BID ADDENDUM 2

Project: Warwick Valley CSD
High School
Renovations, Field Work, Roofing and Exterior Bathroom Building

Engineer: Eisenbach & Ruhnke Engineering, P.C.
291 Genesee Street
Utica, NY 13501
E&R Project #: 05-21-04

16 REVISED WINDOW
SCALE: 0" 1" 2" 4" 8"

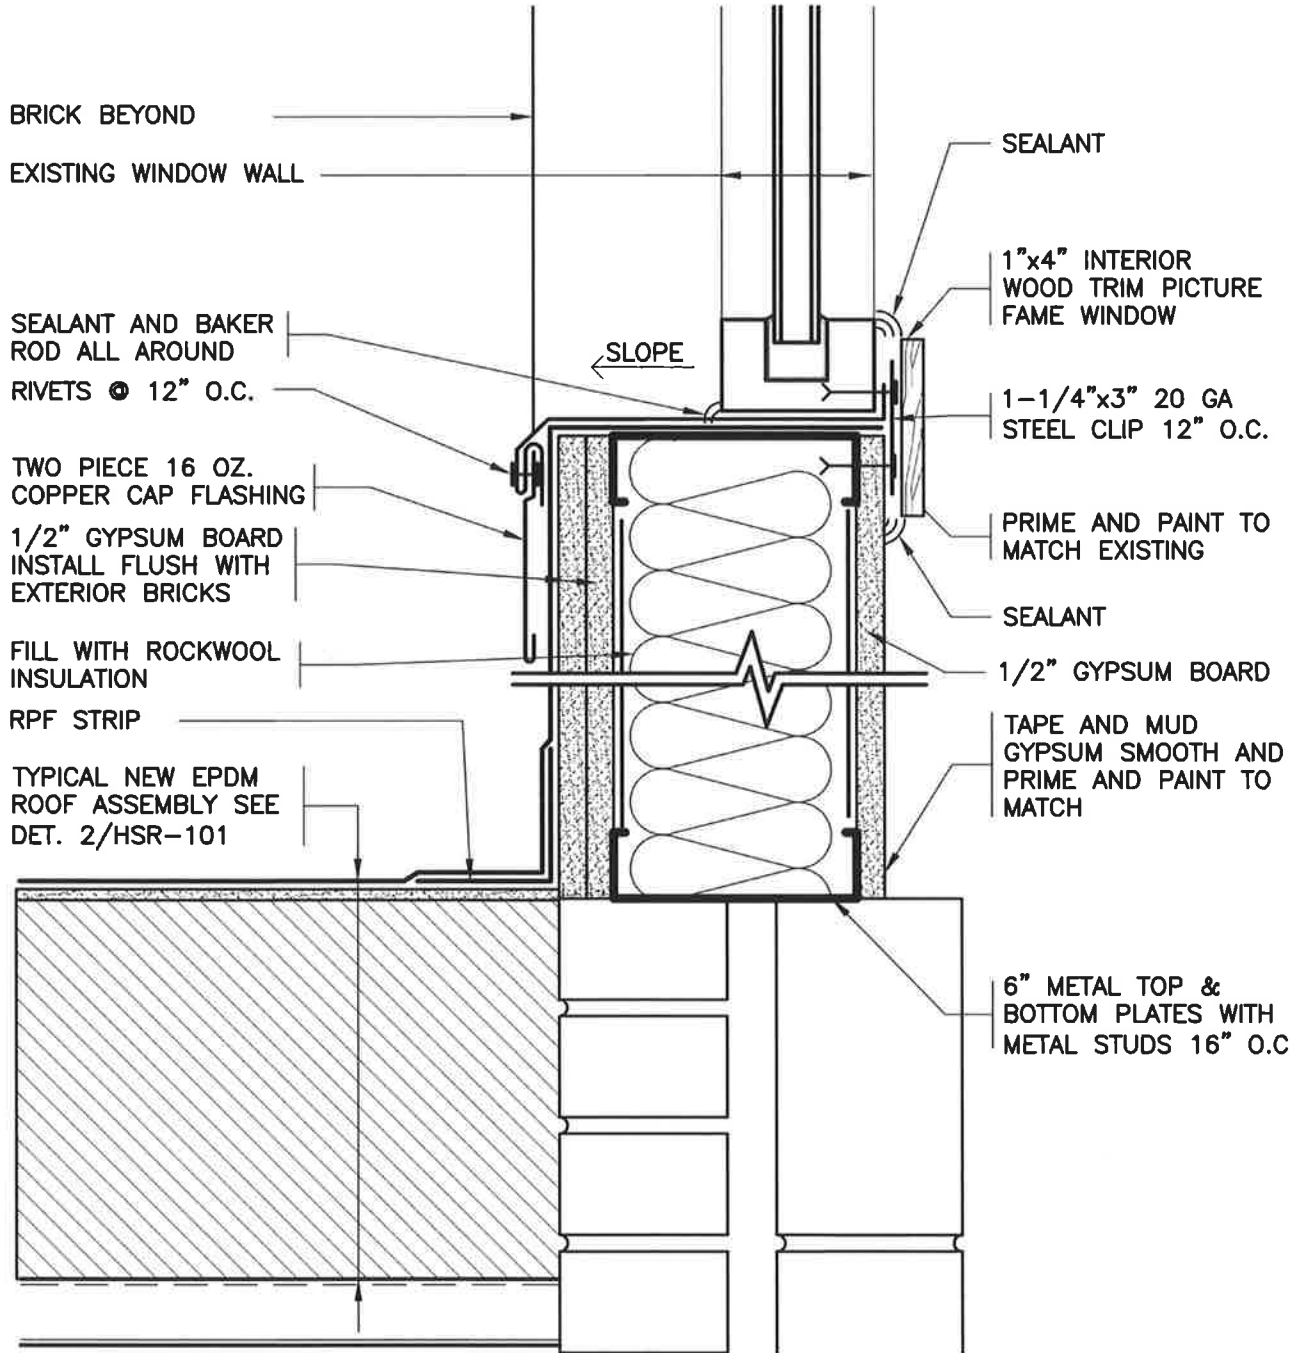
ITEM #1 – Drawing HSR-102

- Delete Detail 15 in its entirety and replace with the attached Detail 15
- Delete Detail 16 in its entirety and replace with the attached Detail 16

- NOTES:
- CAREFULLY CUT THE VERTICAL MULLION AND REMOVE THE BOTTOM ROW OF WINDOWS.
 - REMOVE, RISE, MODIFY AND RESET LOUVERS. INSTALL BACKER ROD AND SEALANT AT LOUVER'S PERIMETER.
